Access Compliance Report

Public Rights-of-Way

Intersection ID: 26692	Main Street: MANOR_HOUSE_DR	Cross Street: MISTY_HILL_LN	Location: S
ADA ID: D2FE9CFBD07F	Ramp Type: Perp	Initial Pass/Fail: Fail	Overall Compliance: No
			Severity Score: 12.5

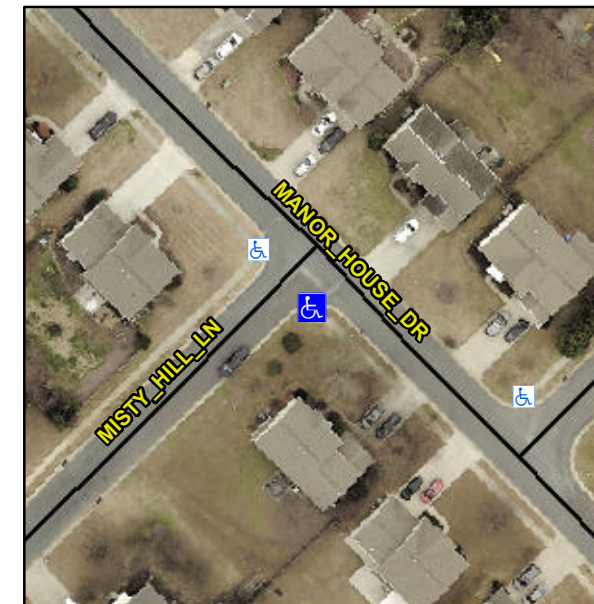
Not Found, R304.5.3

Compliance	Description	Data	Compliance	Description	Data
N/A	Ramp Length (in)	48.0	Yes	Ramp Slope (%)	7.5
Yes	Ramp Width (in)	48.0	No	Ramp XSlope (%)	6.1
N/A	Flare Type LT	N/A	N/A	Flare Type RT	N/A
N/A	Flare Slope LT (%)	N/A	N/A	Flare Slope RT (%)	N/A
N/A	Flare Traversable LT?	N/A	N/A	Flare Traversable RT?	N/A
N/A	Landing Length (in)	N/A	N/A	DWS Provided?	N/A
N/A	Landing Width (in)	N/A	N/A	DWS Contrast?	N/A
N/A	Landing Slope (%)	N/A	N/A	DWS Length (in)	N/A
N/A	Landing X Slope (%)	N/A	N/A	DWS Full Width?	N/A
N/A	Landing Curb? (Y/N)	N/A	N/A	DWS Offset (in)	N/A
N/A	Shared Landing?	N/A			
N/A	Gutter Ponding?	N/A	N/A	Gutter Slope (%)	N/A
N/A	Gutter Lip Ht (in)	N/A	N/A	Gutter X Slope (%)	N/A
N/A	Painted X Walk1?	No	N/A	Painted X Walk2?	N/A
	X Walk 1 Direction	To NW		X Walk 2 Direction	N/A
N/A	X Walk 1 Width (in)	N/A	N/A	X Walk 2 Width (in)	N/A
	X Walk 1 Slope (%)	0.2		X Walk 2 Slope (%)	N/A
	X Walk 1 X Slope (%)	5.3		X Walk 2 X Slope (%)	N/A

Remove & Replace Entire Ramp.
